Central Planning Authority

Minutes of a meeting of the Central Planning Authority held on June 23, 2021 at 10:00am, in Conference Room 1038, 1st Floor, Government Administration Building, Elgin Avenue.

CPA/13/21

Figure 1: The site (outlined in blue) is mostly man-modified (beige/brown) with some areas of seasonally flooded mangrove forest (pink).

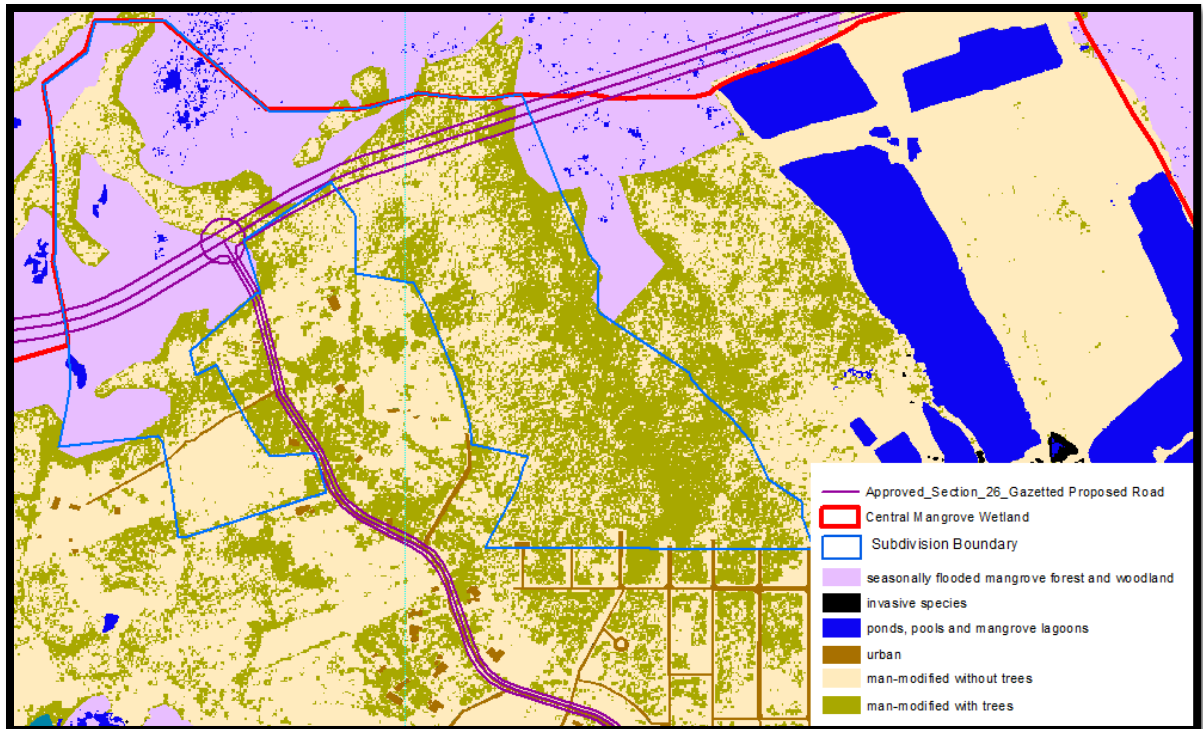
The application site is partially man-modified with areas of primary habitat (seasonally flooded mangrove forest) as shown in Figure 1. The vegetation in the man-modified areas has regrown somewhat and continues to provide an ecological benefit, such as drainage and habitat for native flora and fauna. The application site is also located immediately south of the Boundary of Central Mangrove Wetlands (see Figure 2). Therefore given the size and location of the subdivision, the Department would like highlight the following concerns.

Figure 2: LIS 2018 aerial imagery showing the application site (outlined in blue) and the proposed East-West Arterial road (purple).

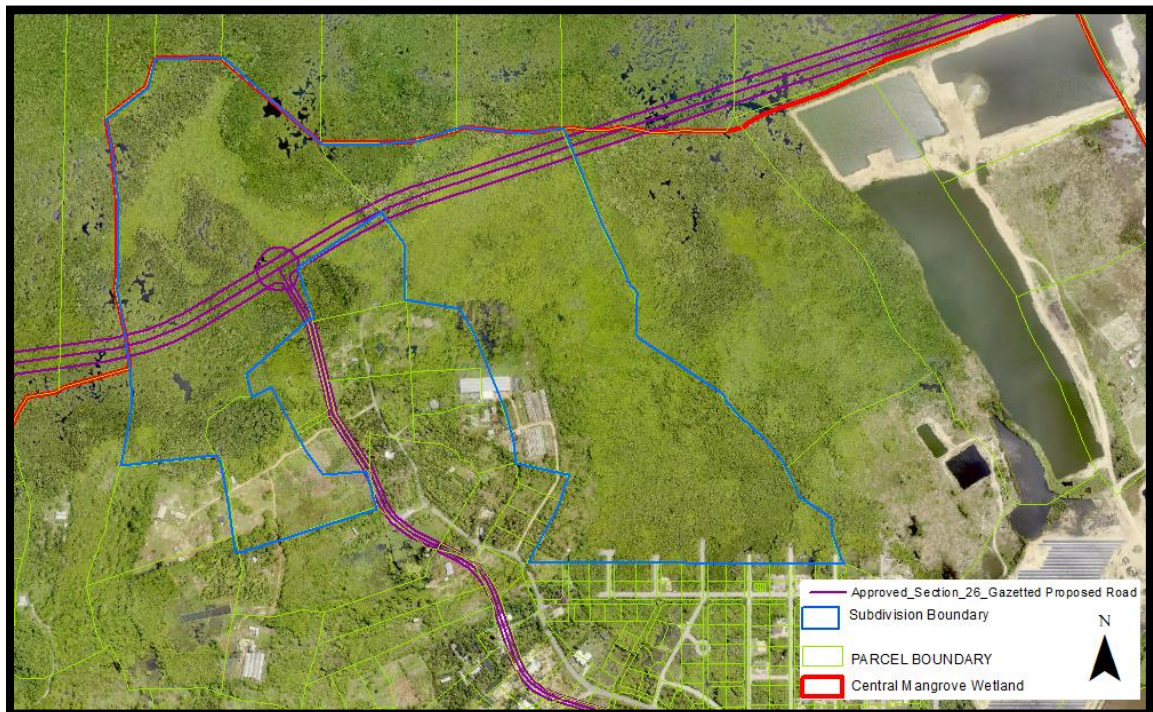
East-West Arterial Road It is noted that the subdivision layout incorporates the proposed East-West Arterial road. The East-West Arterial road is currently the subject of an Environmental Impact Assessment (EIA), due to the potential effects on flooding and drainage of nearby communities and the hydrology of the Central Mangrove Wetland. The road has the potential to act as a dam, and deprive the Central Mangrove Wetland of water (affecting its ecology but also the ecosystem services it provides to people) and flood neighbouring communities (such as Lookout Gardens). The EIA will determine the best location to put the road and will determine the design required to maintain a suitable hydrological regime. This may include changing the road layout.

The East-West Arterial from Woodland Drive to Harvey Stephenson Road has been through the EIA screening stage and the EIA scoping stage. The next step in the EIA process is the preparation of the Terms of Reference. However, at the request of the Ministry of Commerce, Planning and Infrastructure (CPI) the scope of the EIA only covers the portion of the road from Woodland Dr to Harvey Stephenson Rd, and not further east. Based on a decision reached at the National Conservation Council's Special General Meeting on 26 October 2016, the section east of Lookout Gardens will require an EIA when the Ministry of CPI/the National Roads Authority chooses to pursue that section of the road.

The outcome of the EIA could impact the subdivision, and the subdivision may also impact the outcome of the EIA. The applicant may have to redesign parts of the subdivision should the location of the road change. Therefore, in the Department's opinion, it is considered that approving the subdivision application without knowing the outcome of the EIA is premature, and would recommend that the application be held in abeyance until the EIA is finalised. A phased approach could also be undertaken, starting with a phase in the south which is not likely to be directly impacted by the final layout and design of the road.

Figure 3: An extract of the Plan over the LIS 2018 aerial image, with the Central Mangrove Wetland boundary (orange red line).

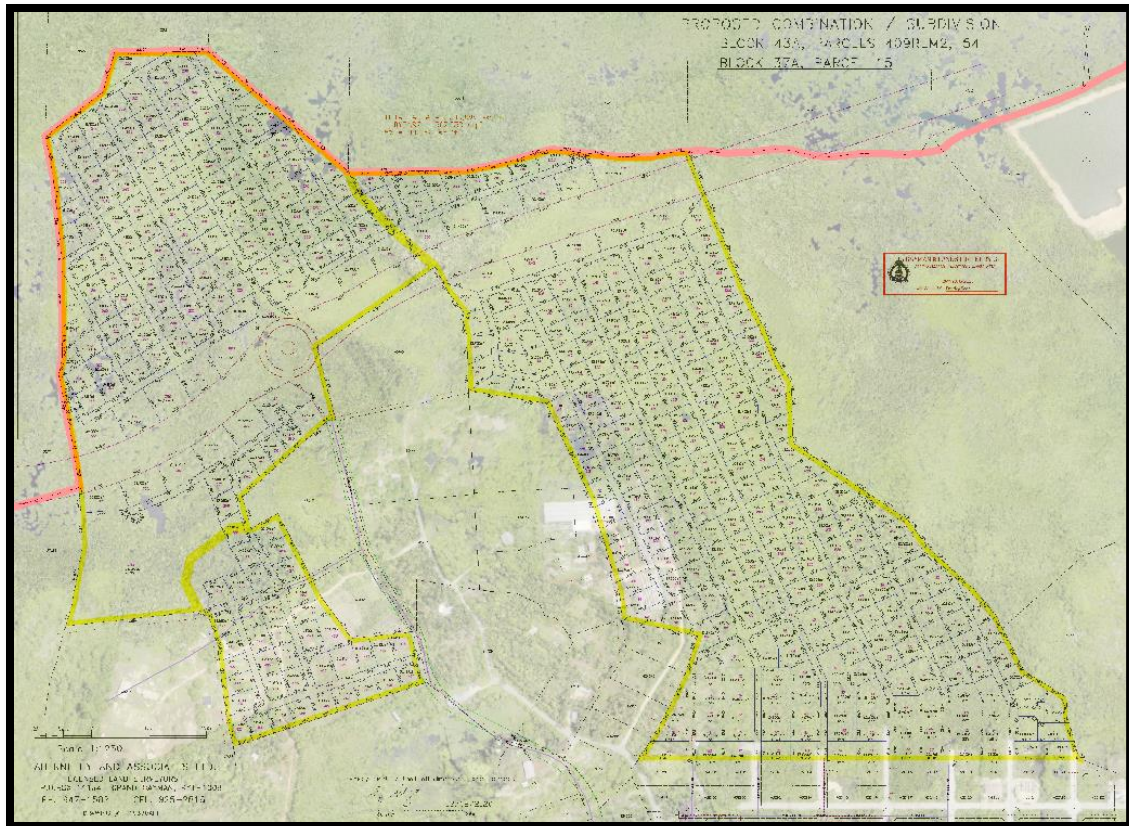
This subdivision would contain 437 residential lots with one LPP and 3 road lots, and would eventually have an impact on the existing social infrastructure such as schools, clinics, supermarkets and roads (traffic) in the area. The Department is concerned that existing infrastructure will not be able to accommodate a full build-out of the subdivision. The subdivision divides the lands into small residential lots suitable only for single family homes, duplexes or potentially small apartment buildings. There is little provision for a variety of housing and uses. Therefore this should be taken into consideration when reviewing this application. In addition, the Department has concerns in regards to the demand for such a subdivision at this time, as there have been other large scale subdivisions that have been recently granted approval and remain under-developed. There are often adverse effects on the environment now, but yet homes are not constructed for years (sometimes decades).

The Development Plan is severely outdated. It does not reflect accurately how the island should be developed moving forward taking into consideration the population size, projected population growth, the environment and climate change. Therefore, without an updated development plan for the islands, there is no vision on how the island should progress in terms of development. This can result in unnecessary fragmentation of pristine habitats and loss of valuable limited resources (such as land and associated ecosystem services). It is recommended that prior to approval of this subdivision, the supply and demand of residential lots should be determined. The current Lookout Gardens Subdivision is approximately 40% built out, which raises the question of the need for the proposed subdivision development when more than 50% of the existing subdivision remains undeveloped and within the ownership of the original developer.
